STATE OF CONNECTICUT  
CONNECTICUT SITING COUNCIL

APPLICATION OF NEW CINGULAR WIRELESS PCS,  
LLC (AT&T) FOR A CERTIFICATE OF  
ENVIRONMENTAL COMPATIBILITY AND PUBLIC  
NEED FOR THE CONSTRUCTION, MAINTENANCE  
AND OPERATION OF A TELECOMMUNICATIONS  
TOWER FACILITY LOCATED AT THE FIRSTLIGHT  
HYDRO GENERATING COMPANY PROPERTY AT  
KENT ROAD IN THE TOWN OF NEW MILFORD,  
CONNECTICUT

DOCKET NO. 444

NEW CINGULAR WIRELESS, PCS LLC (AT&T) RESPONSES TO CONNECTICUT  
SITING COUNCIL PRE-HEARING QUESTIONS SET II

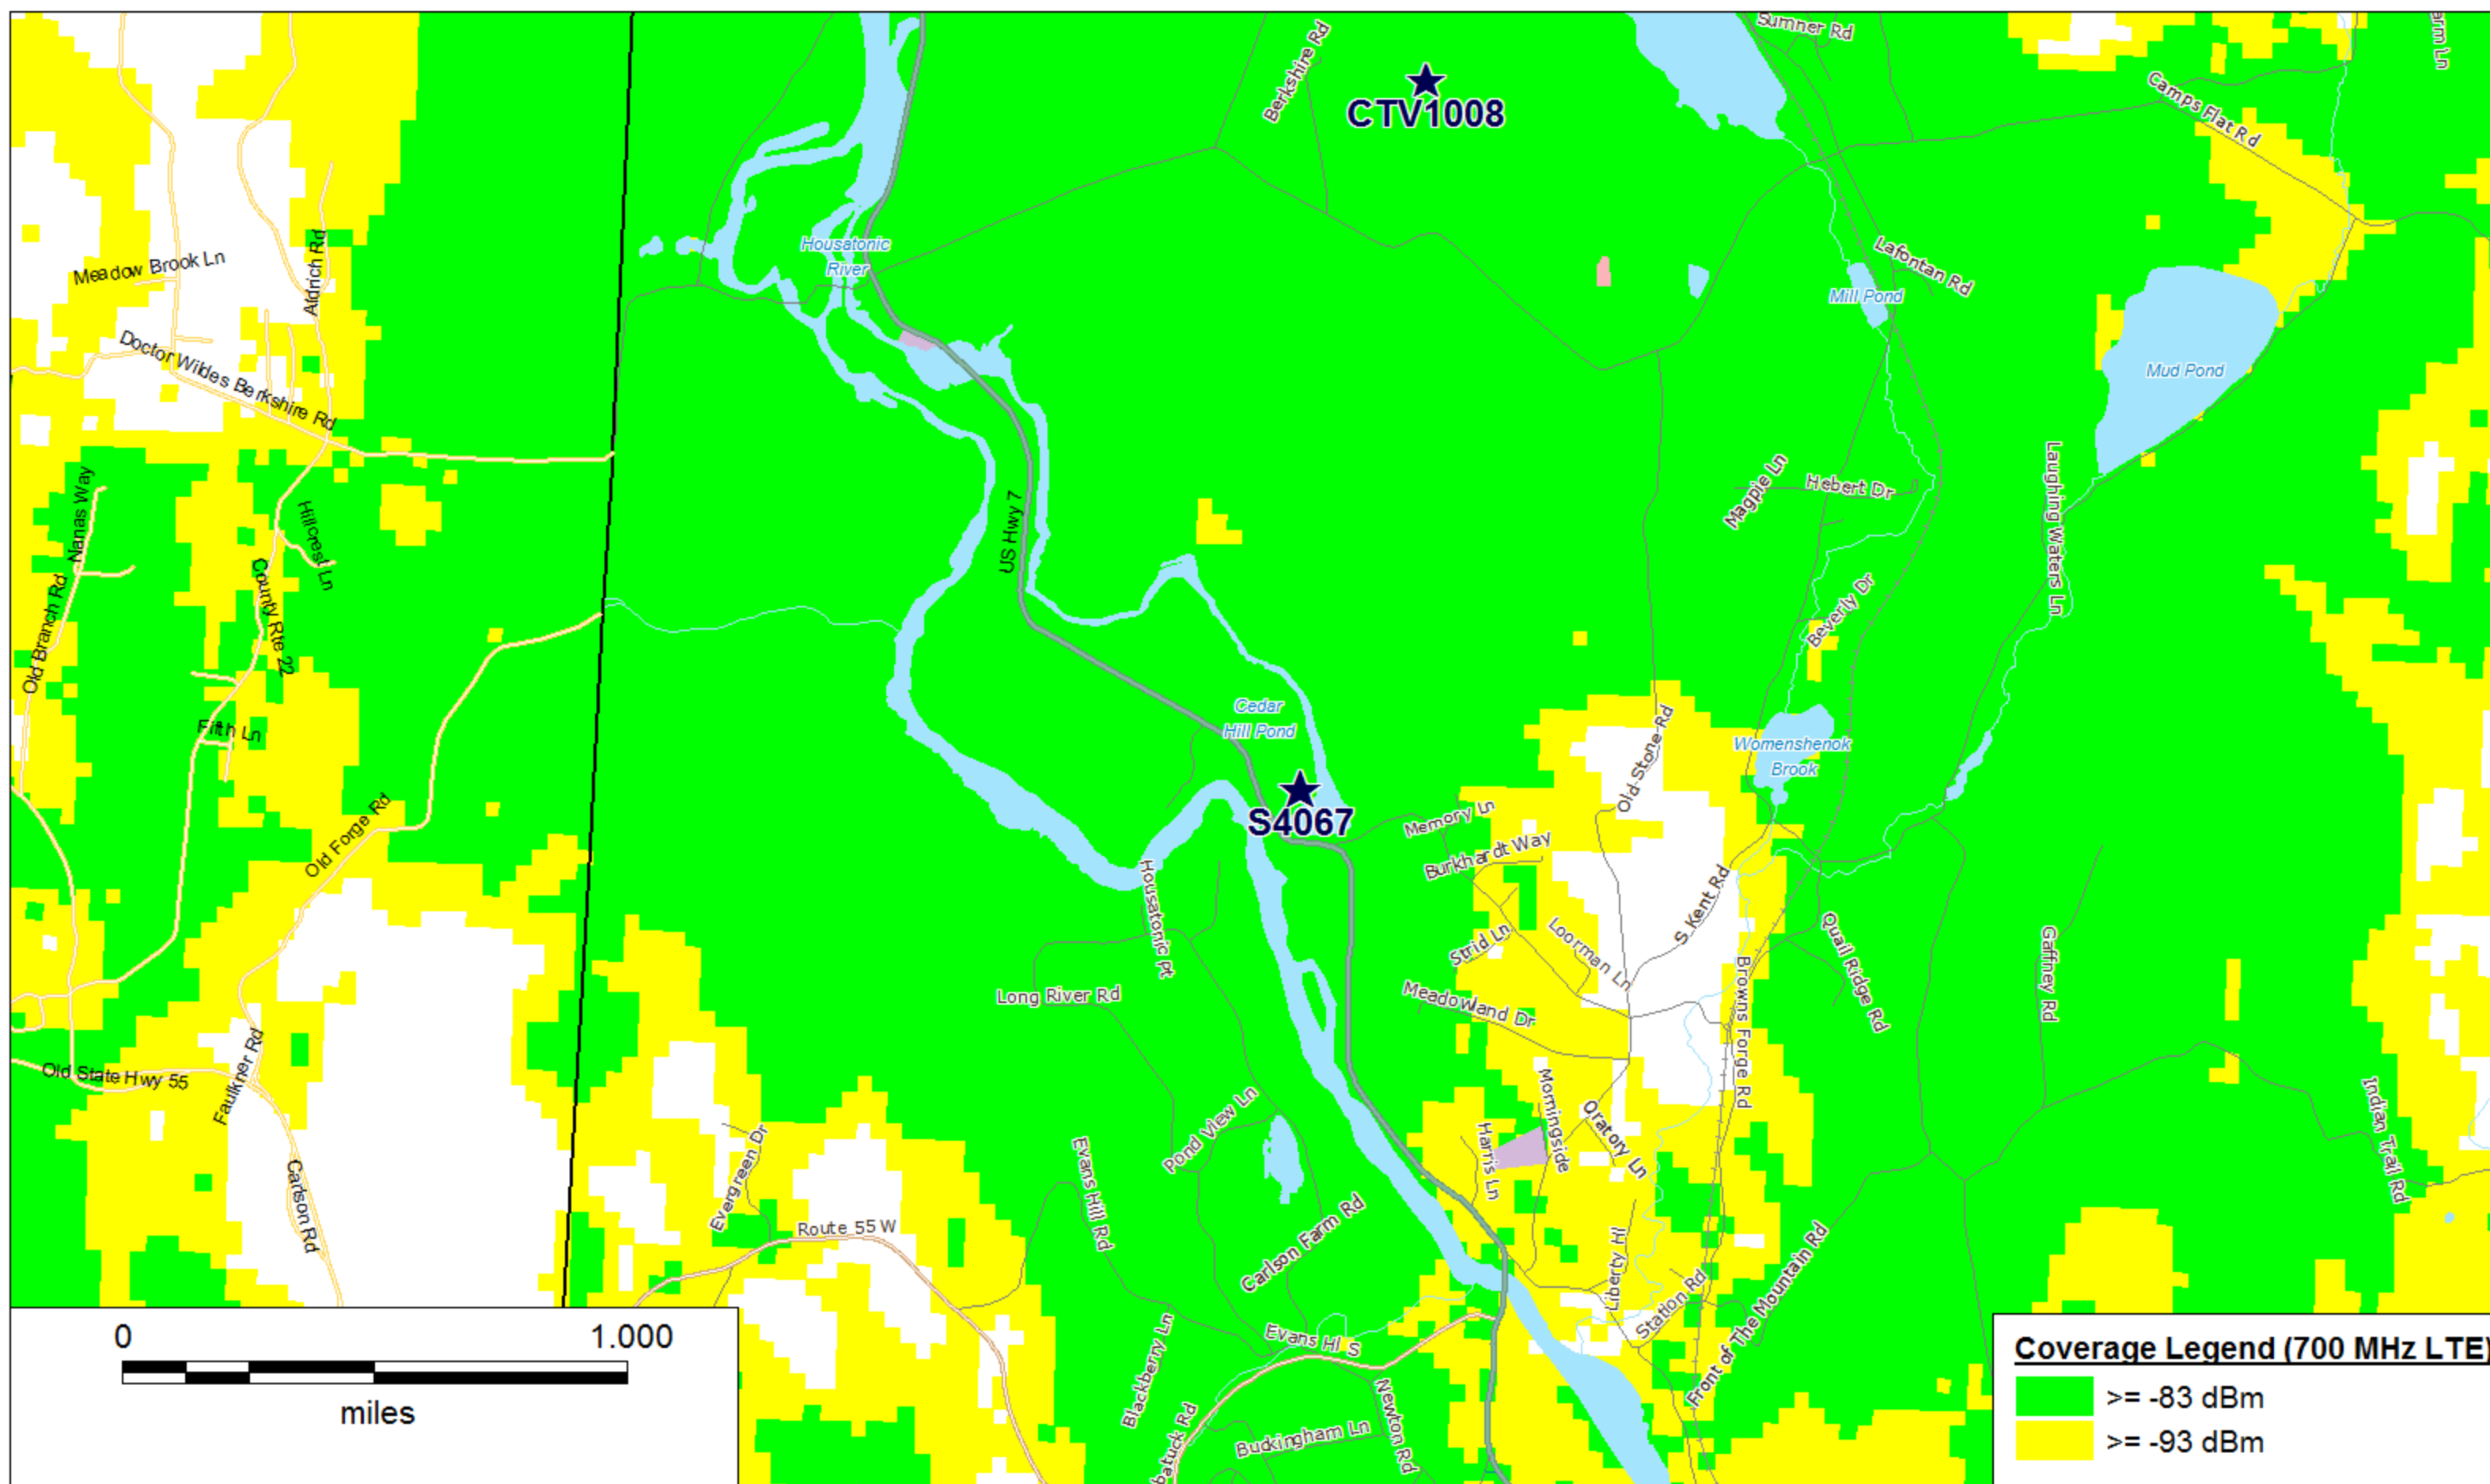
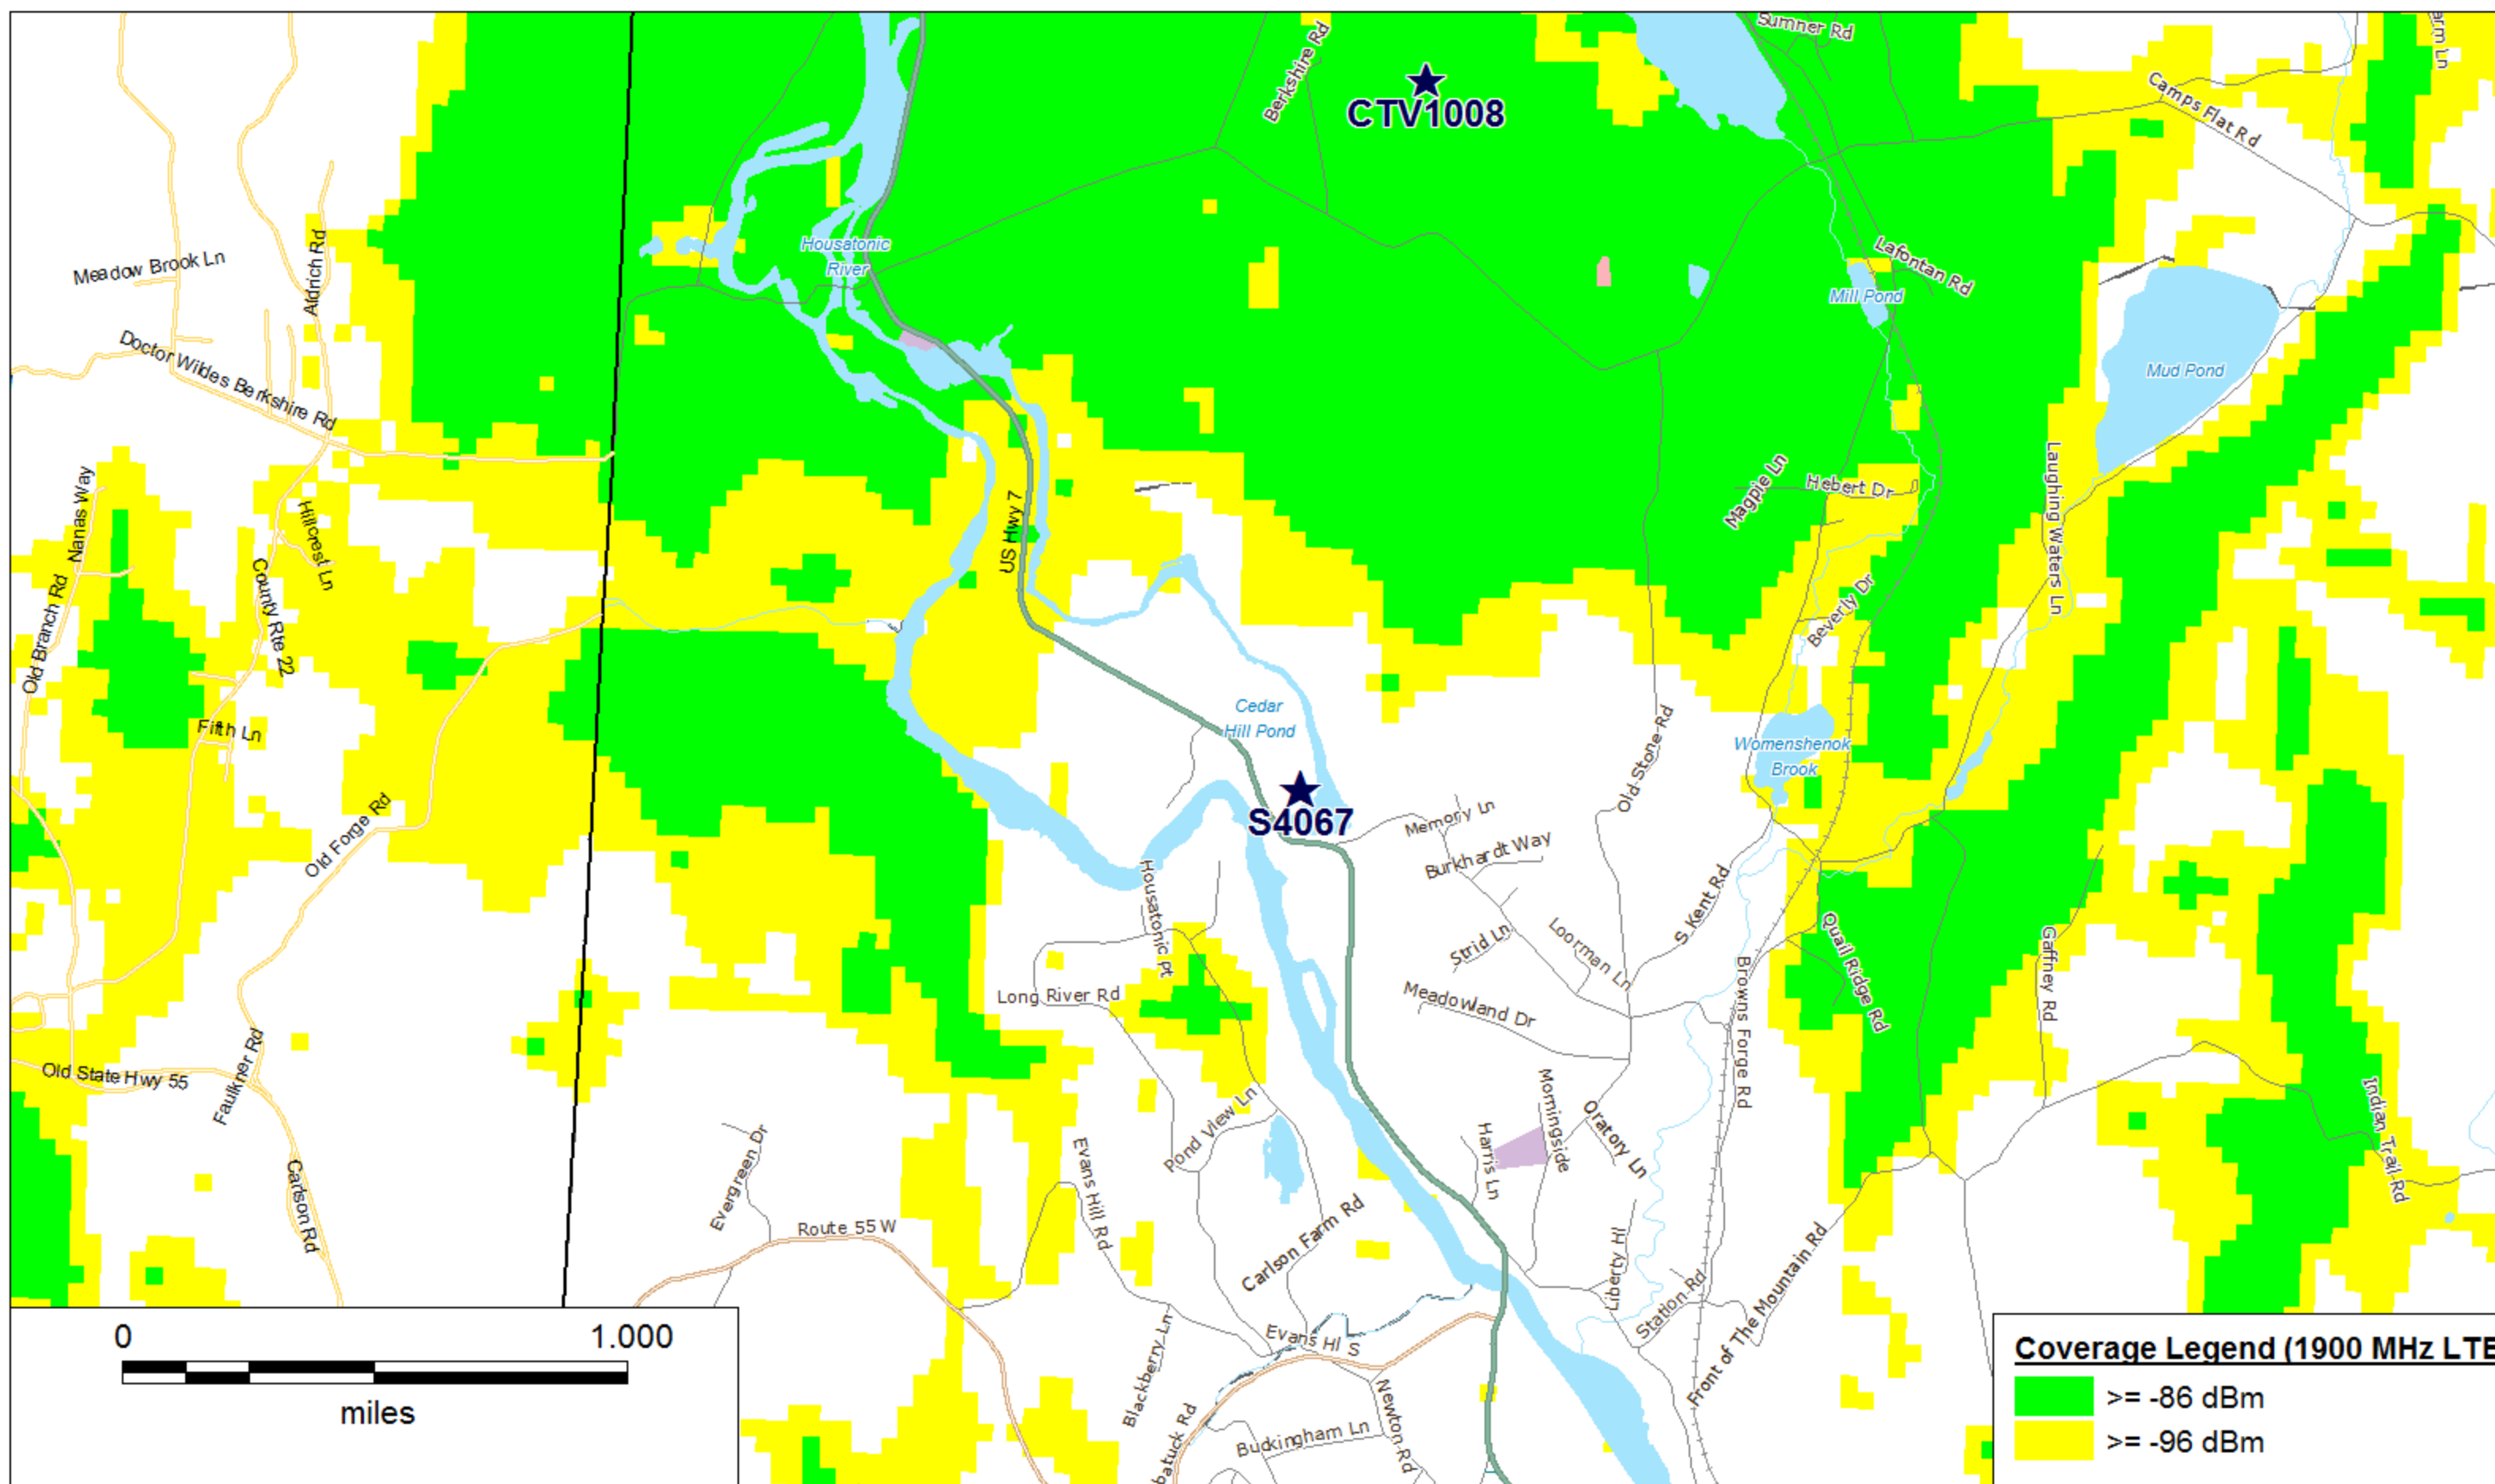
Q48. Using the same scale as the previous coverage plots, provide existing coverage plots for LTE and PCS. Also include LTE and PCS coverage plots depicting the existing and proposed coverage.

A48. Please see the coverage plots included in Attachment 1.
